Project Number: W-2006-0097  
PWSID#: 74401261  
DNR Region: NOR  
County: ONEIDA

SUBJECT: WATER SYSTEM FACILITIES WELL SITE APPROVAL.

Subject: Well Site Investigation Report  
New Well No. 7 - City of Rhinelander, Wisconsin

PROPOSED WELL #7 SITE PLAN AND PROFILE

**SITE PLAN**

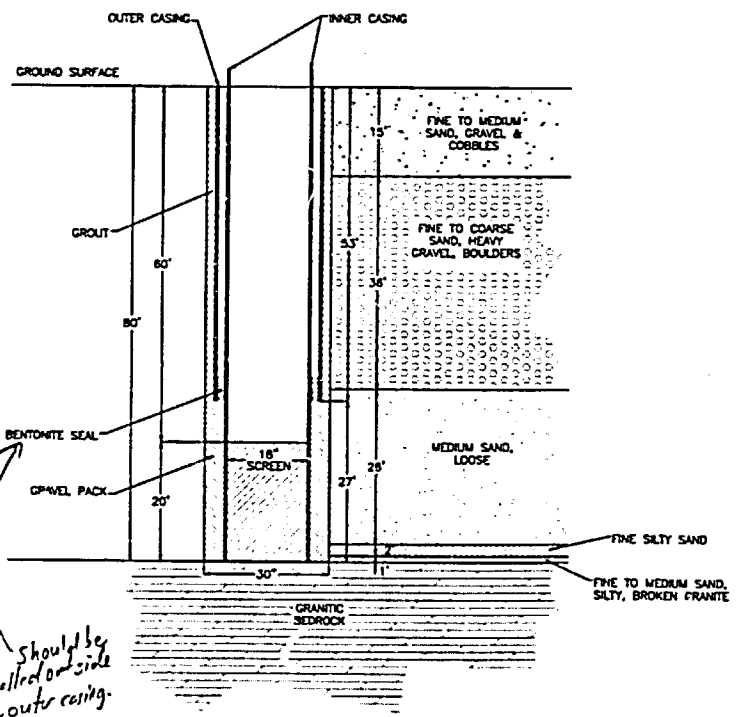
- Please submit a profile drawing of the proposed well. Response: *A profile drawing is included on the site map. As per our discussions, the gravel pack is proposed to be extended to about seven (7) feet above the top of the screen. The depth of the grout will be fifty-three (53) feet below grade.*

*Should be installed outside the outer casing.*

PLAT BOOK MAP

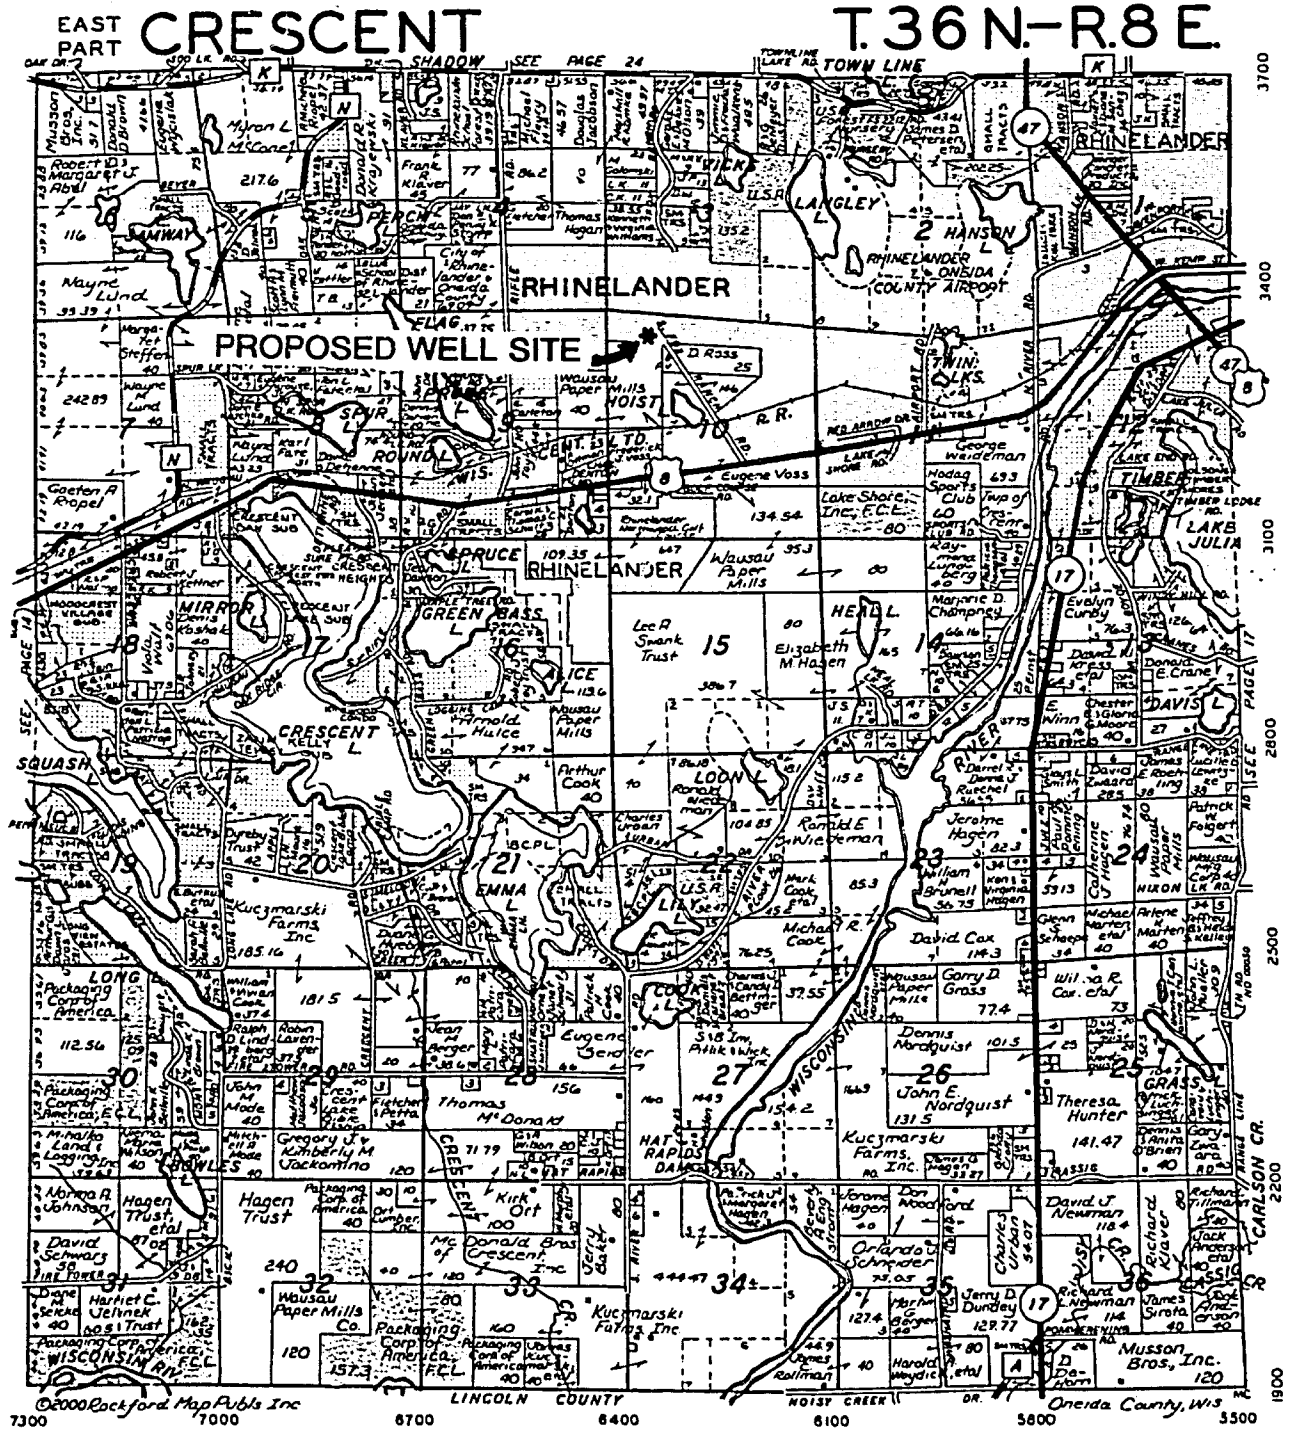
- Is the proposed well location in the NW ¼, NW ¼, Section 10, or the NE ¼, NW ¼, Section 10 as indicated on Page 7? Response: *The well will be located in the NW ¼, NW ¼, not in the NE ¼, NW ¼, Section 10 as indicated on Page 7. This is a typographical error and we ask that you so correct Page 7 of the submitted report copies.*
